**Addendum for Request for Proposal
Council Chambers Video Production System**

14-861

Date: 08/30/2013
From: Lisa Moss, Buyer VCA
RE: Addendum No. 1

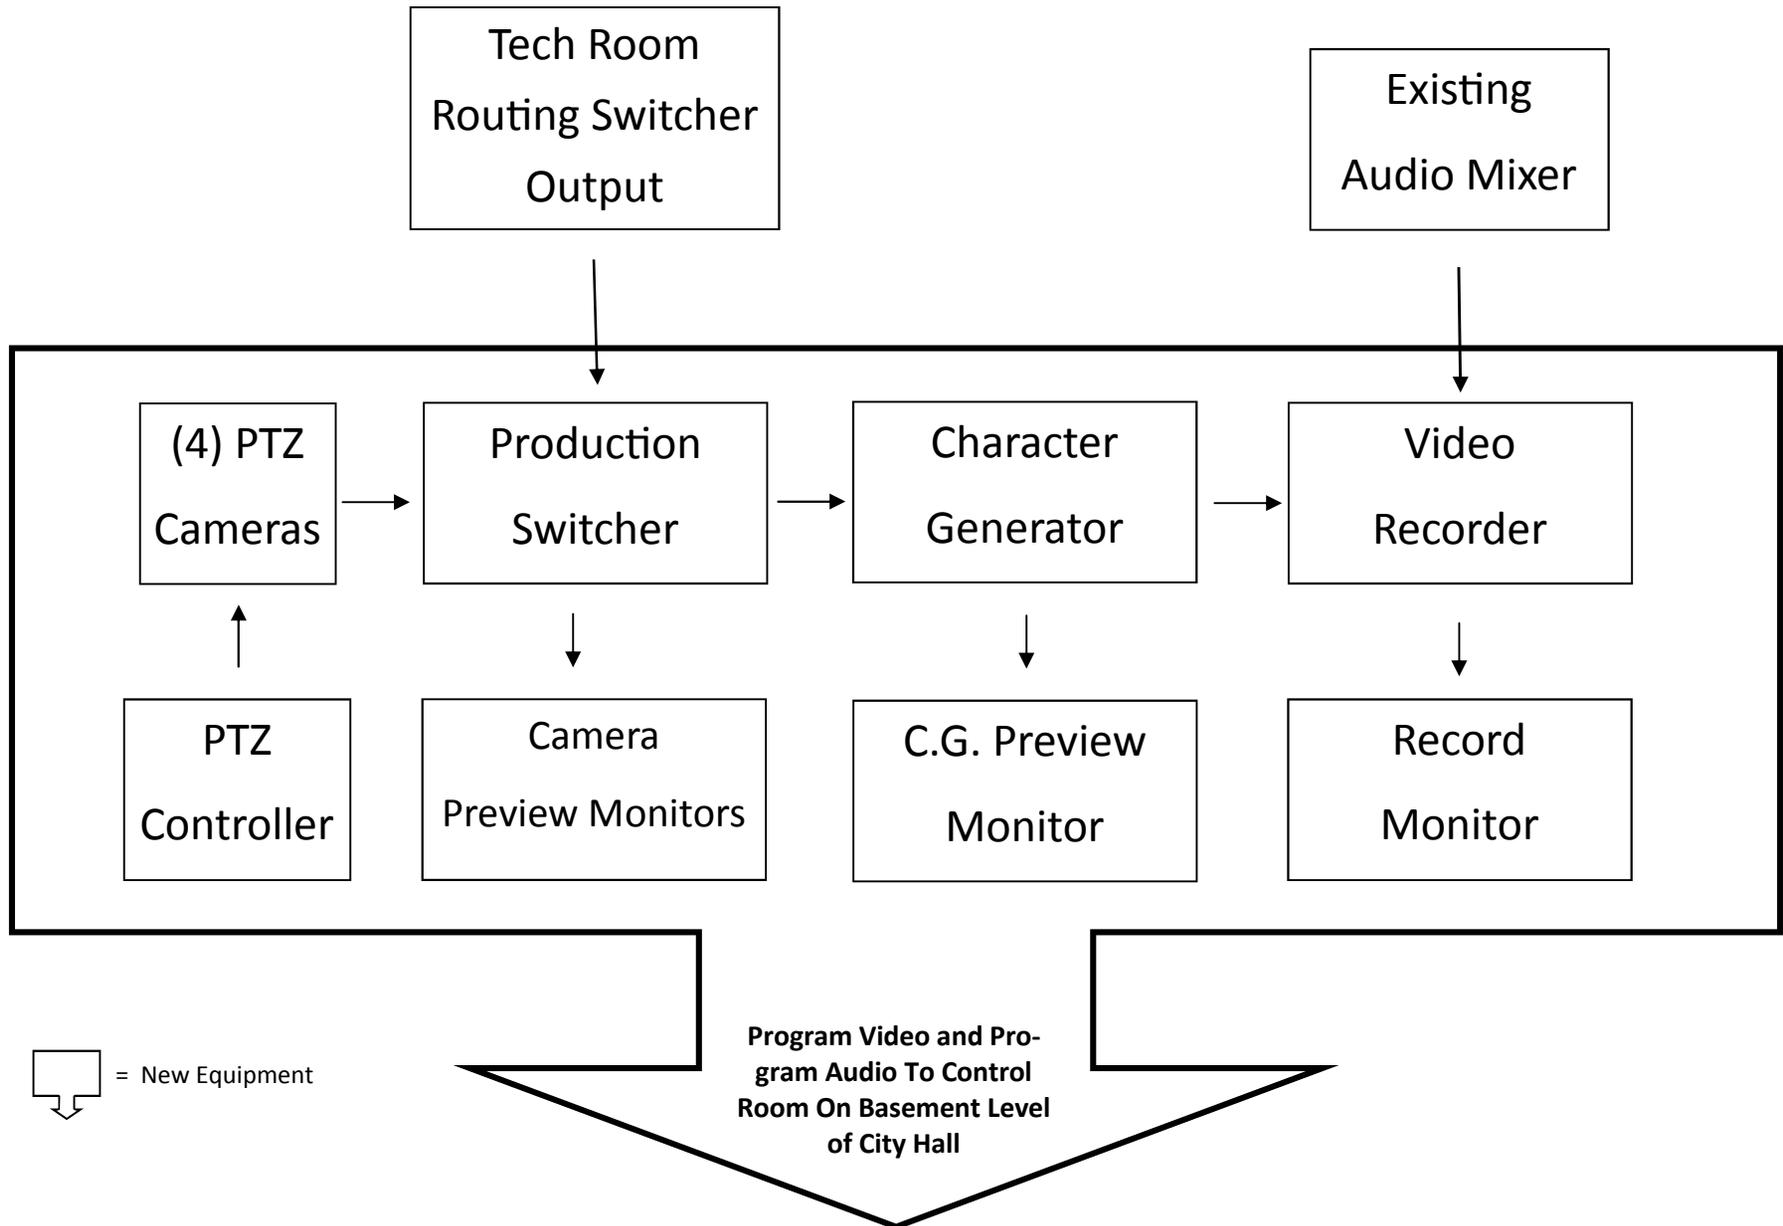
34. Are there current system drawings?

35. Is there a drawing of the Video Control Room and Council Chambers with complete wire runs labeled?

Yes. See Attachments

Yes. See Attachments
